## **ALERT SERVICE BULLETIN**

<b>IMPORTANCE</b>	Critical
<b>AREA AFFECTED</b>	FLIGHT CONTROLS
<b>SB SERIAL NUMBER</b>	Cheetah/003/12-2009

**SUBJECT:** Elevator control arm and tie brace

**OLD STYLE  
(HIGHLY  
AFFECTED BY  
THIS SB)**

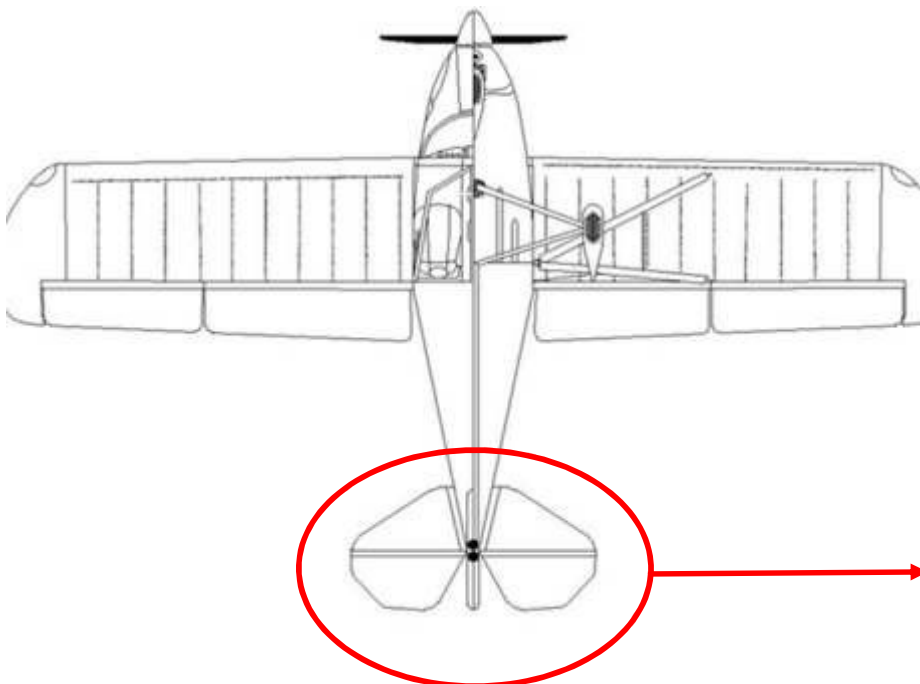
Cheetah/XL/XLS aircraft with old style (shape) Elevator (Highly advisable that all aircraft be inspected), as shown in figure below. The old style elevator puts more force on the tie rod flange than the new style.

**If your Cheetah is equipped with this old style of elevator and has accumulated more than 500 flight hours it is grounded read further to find solutions to this Alert SB..**

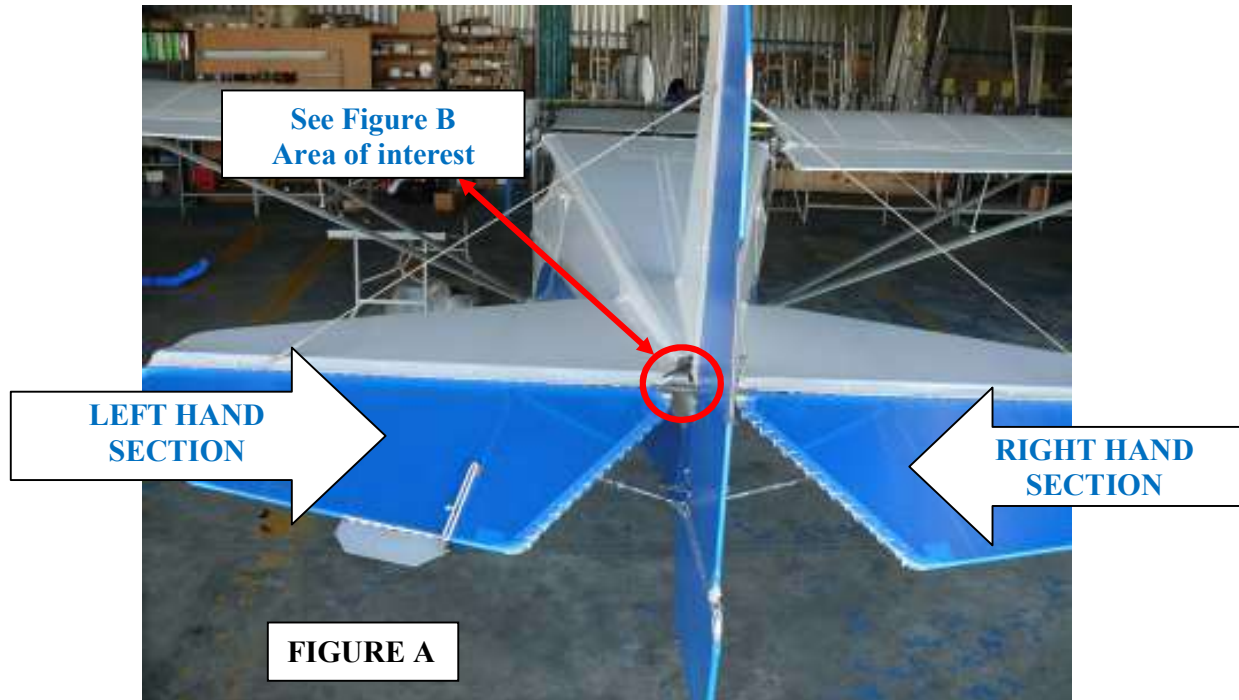
Cracked of flanges on LH elevator tie rod. This failure will affect flight characteristics and could lead to serious accident.

On a recent pre-flight inspection on an Cheetah XLS with the old style elevator, We have found that the tie bracket that connects the left hand section of the elevator to the right hand section (Figure A) of the elevator was cracked off.

Due to the amount of flight hours accumulated on this aircraft it was found that this tie point has cracked off because of fatigue.

#### **OLD STYLE Elevator**

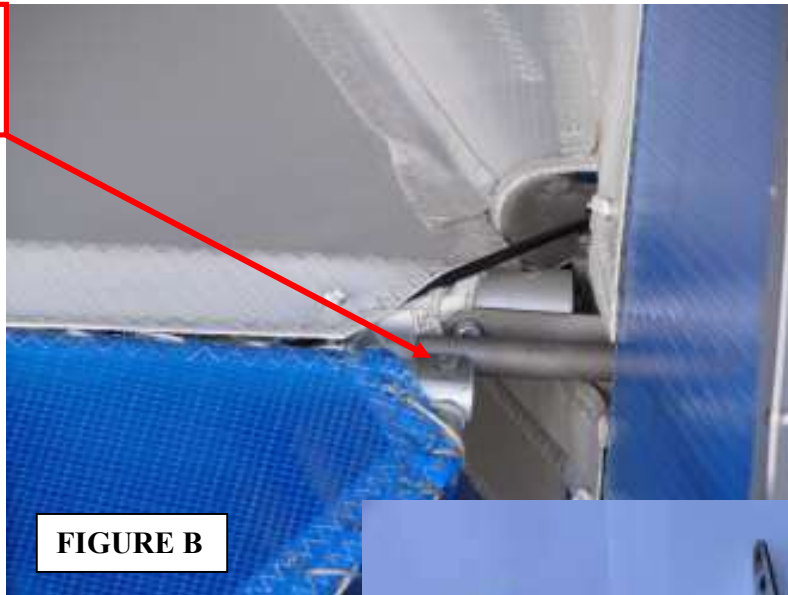
This is the area where the tie rod flanges cracked off.

This is the area where the tie rod flanges cracked off.

This tie rod needs to be replaced with a newly designed tie rod as shown in figure C as indicated in paragraph 1d.

- 1) If your cheetah is equipped with the old style elevator and has accumulated more than 500 flight hours you are not allowed to fly (**Grounded**) until this tie rod has been replaced.
- 2) If your cheetah is equipped with the old style elevator and has accumulated less than 500 flight hours you have to inspect the tie rod flanges for cracks in the areas indicated in the figures A and B every pre-flight. Should there be any evidence of cracks you are NOT allowed to fly further (**Grounded**) until this tie rod has been replaced.

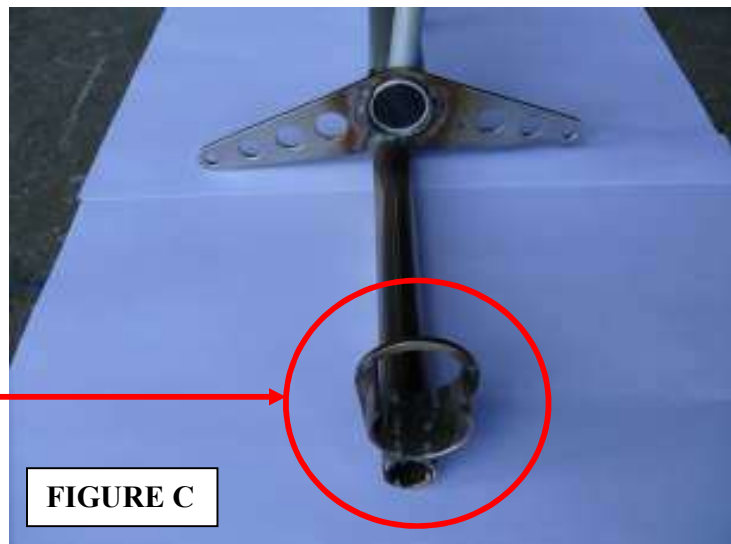
New design of attachment that must be replaced as soon as possible.

As per Figure C new remanufactured tie rod.
